AGENDA
ATHENS CITY COUNCIL
MONDAY, SEPTEMBER 11, 2023
7:00 PM
e-mail: dwalker@ci.athens.oh.us
Streaming is available at www.ci.athens.oh.us/video

Case #23-02 Homestead Court and Broadmoor Planned Unit Development

University Estates Planned Unit Development (PUD) Homestead Court and Broadmoor

**City of Athens Engineering and Public Works
Private Development Plan Review Response Summary**

INTERNAL SANITARY BOWL DROP CONNECTION DETAIL
NO SCALE

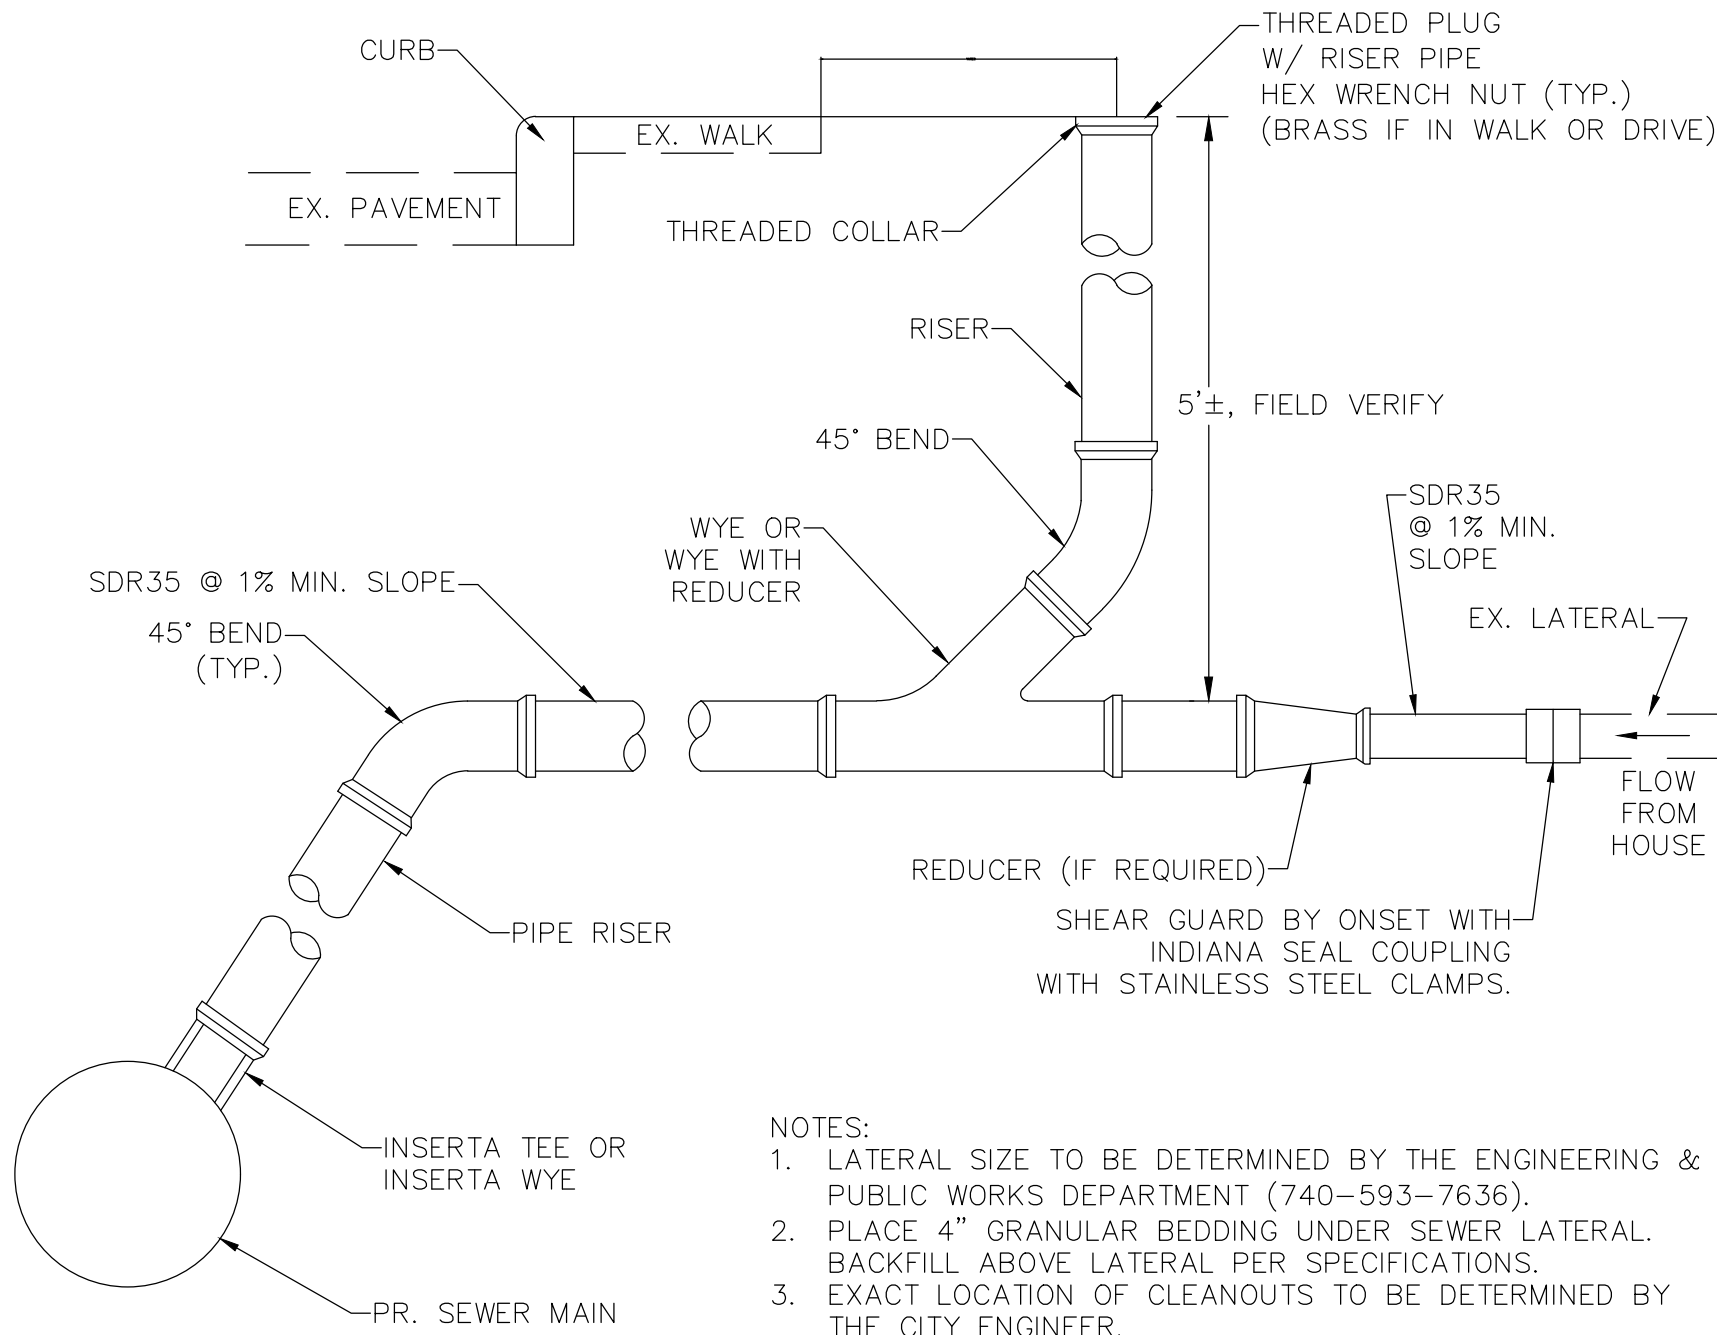
1. Please review depth of the proposed sewer to determine if it can be shallower.
Sanitary sewer shallowed where possible, see revised plan and profile.
2. Please change the external drop manhole detail to an internal bowl drop manhole.
Detail changed.
3. Provide copies of the OEPA Permit to Install Approval for city records.
Will provide upon OEPA approval.
4. The contractor/developer should provide 48 hours of advance notice to the City Engineering and Public Works Department to witness installation and testing of the sewer line.
Note Added to Sanitary General Notes sheet and sanitary sewer plan and profile sheet.

DRWN. CDK CHCK. CDK
JOB NO. 201656
SHEET NO. C-5

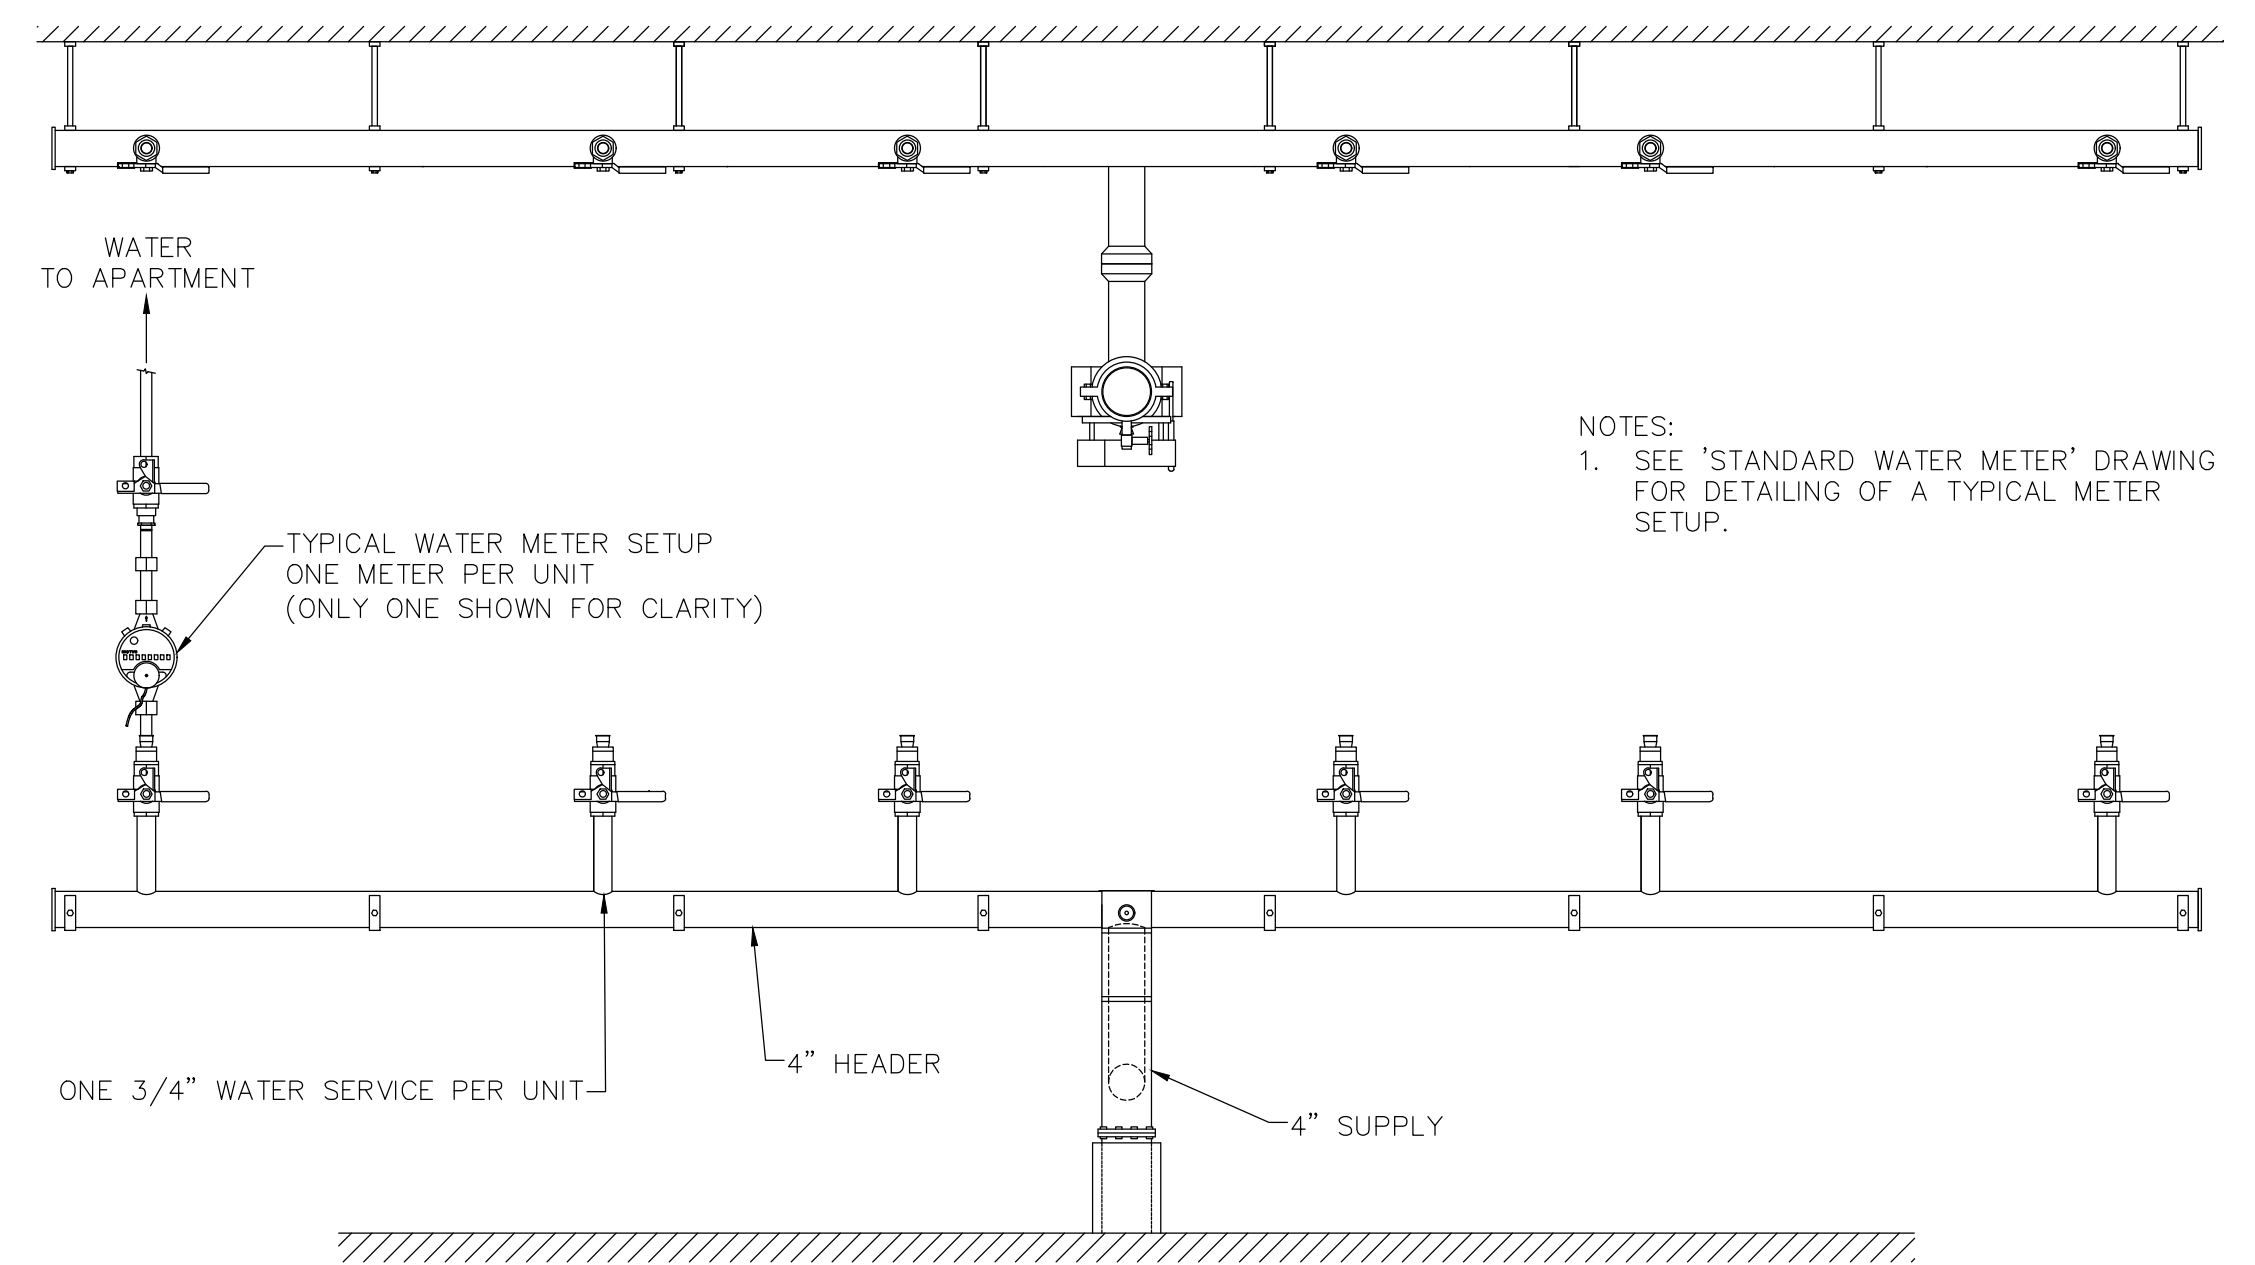
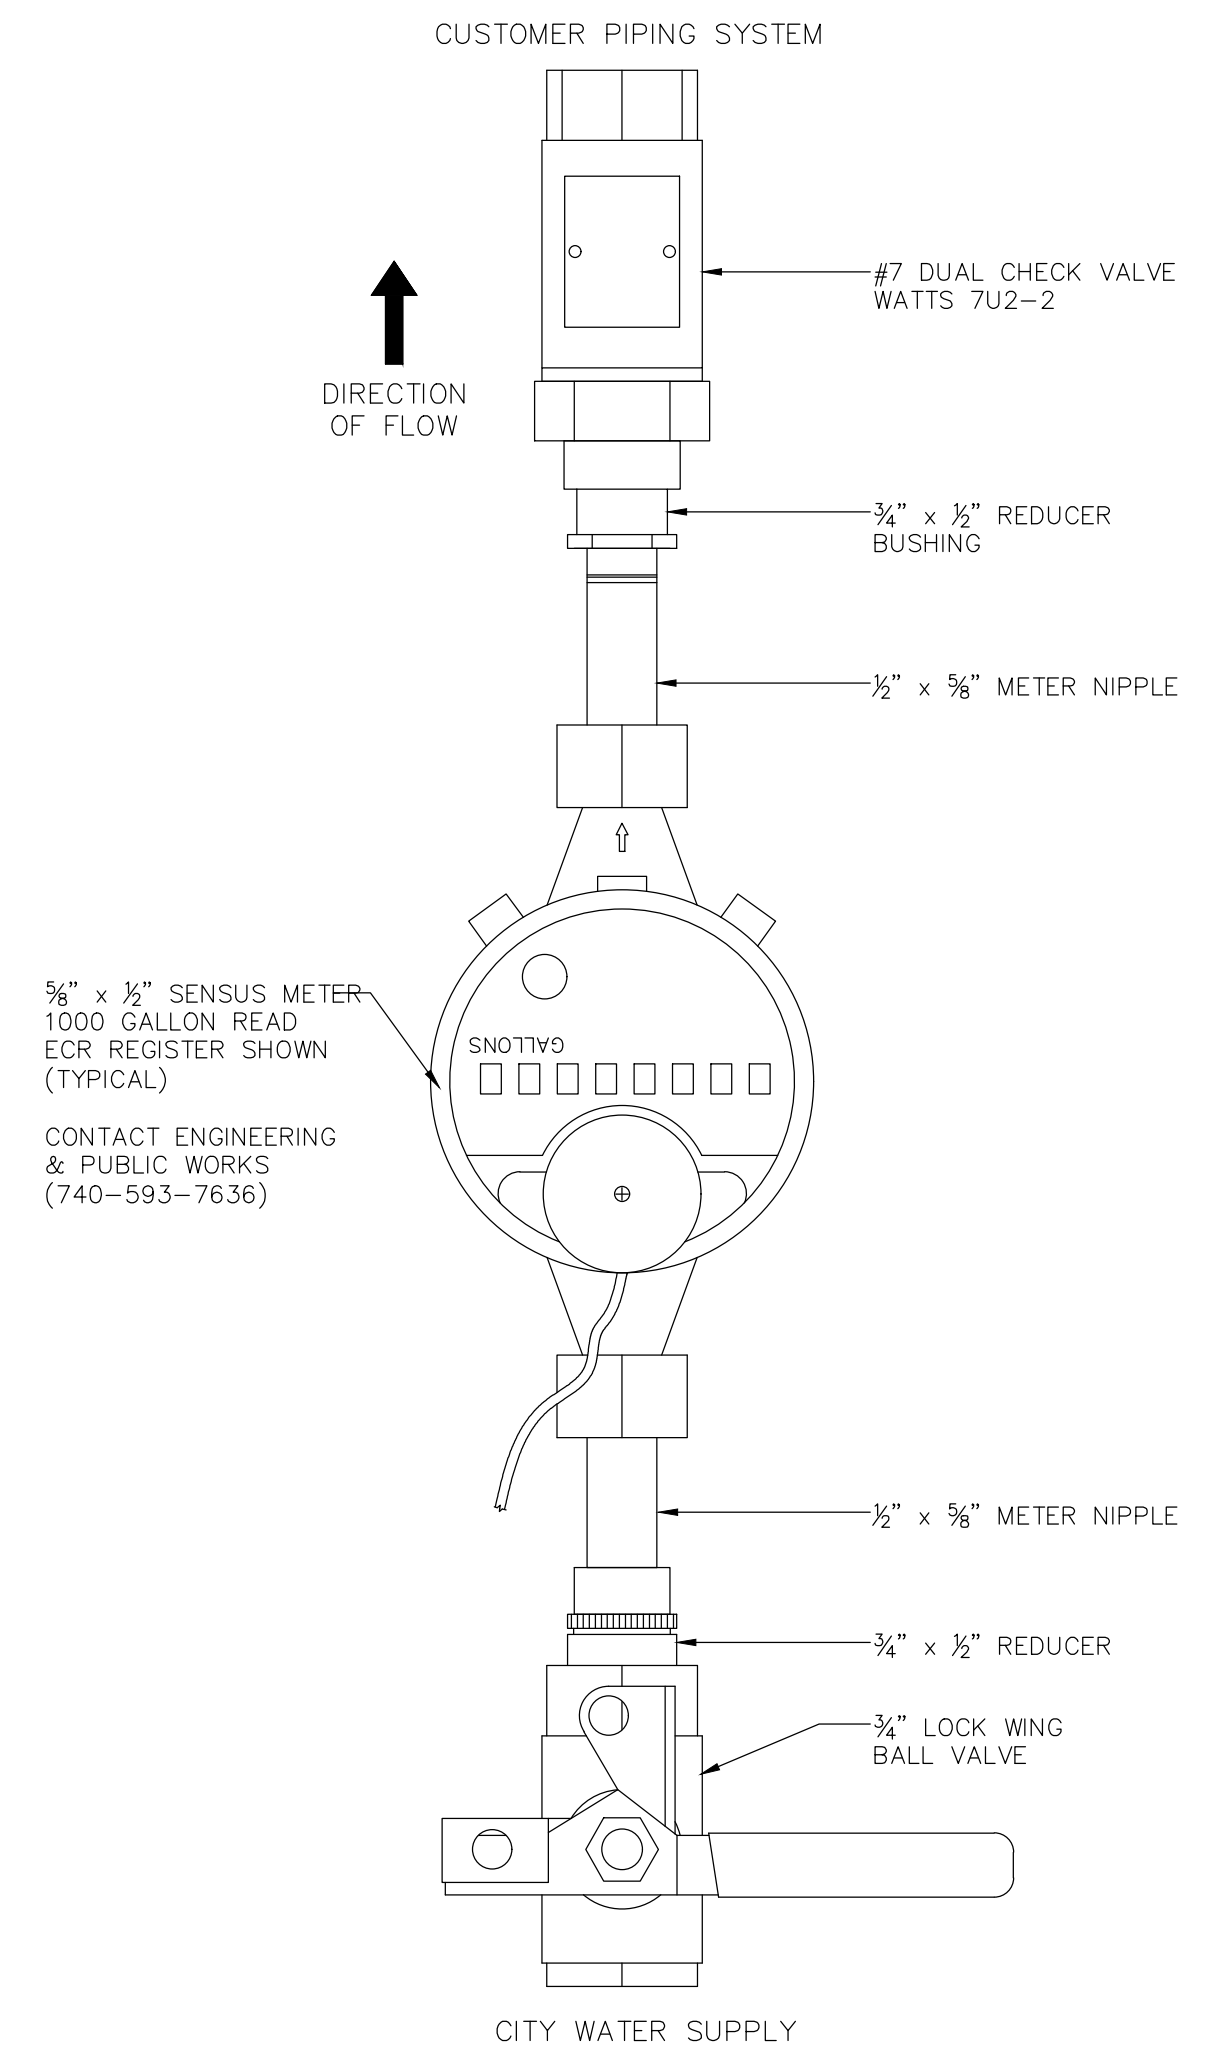
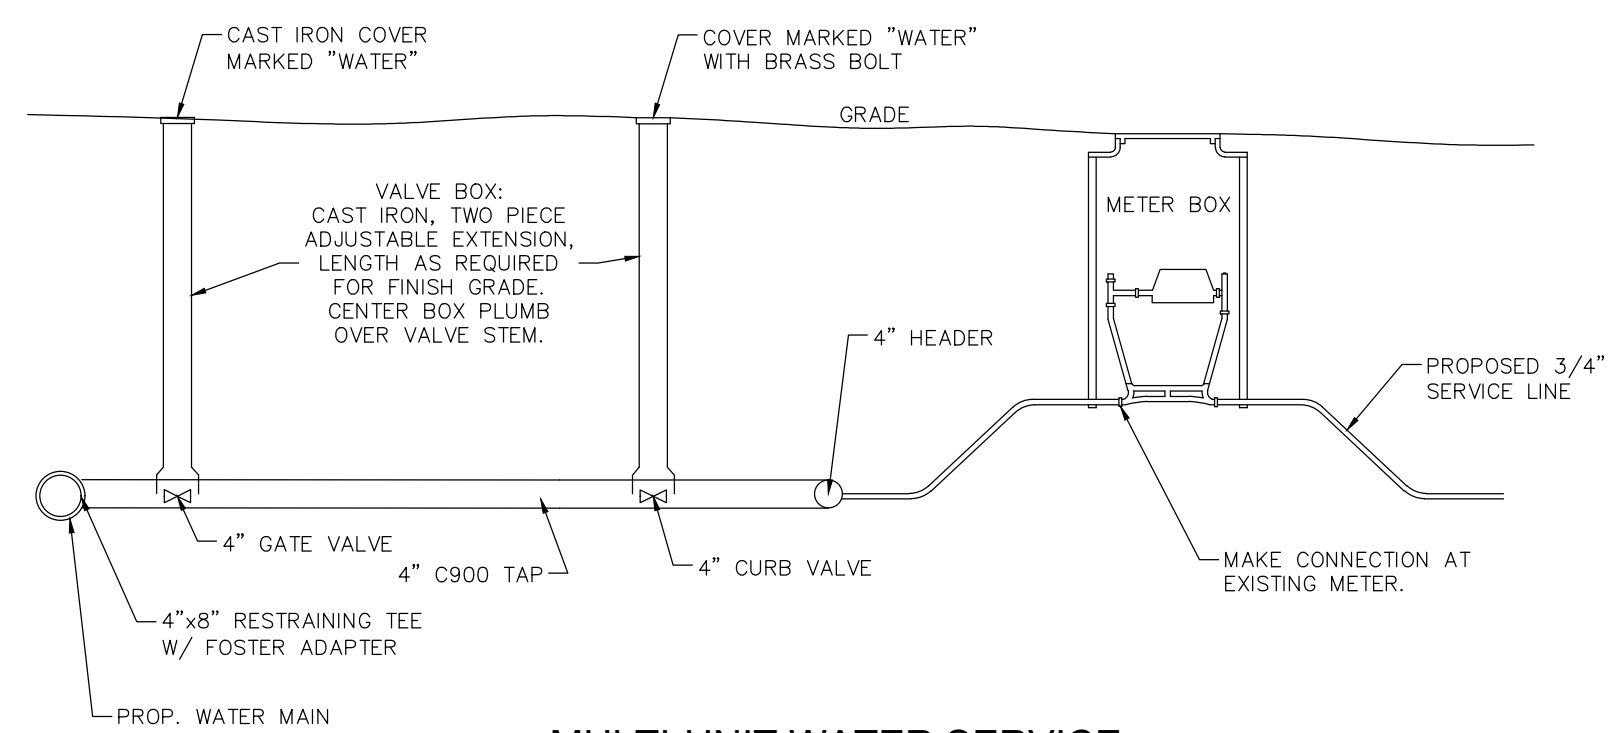
- Andy S: Requested utility tap information.
 - Clinton Kuenzli/The Buckley Group noted that this detail is available on page C-5 of the plan. (This page was not provided prior to the meeting so he shared this plan page with the commissioners.)

1. Provide additional information on the location of the water meters. Will these be installed in a mechanical room?
Plans updated to show water meters.
Please provide an updated meter detail with the standard setter.
Coordinating with EPW.
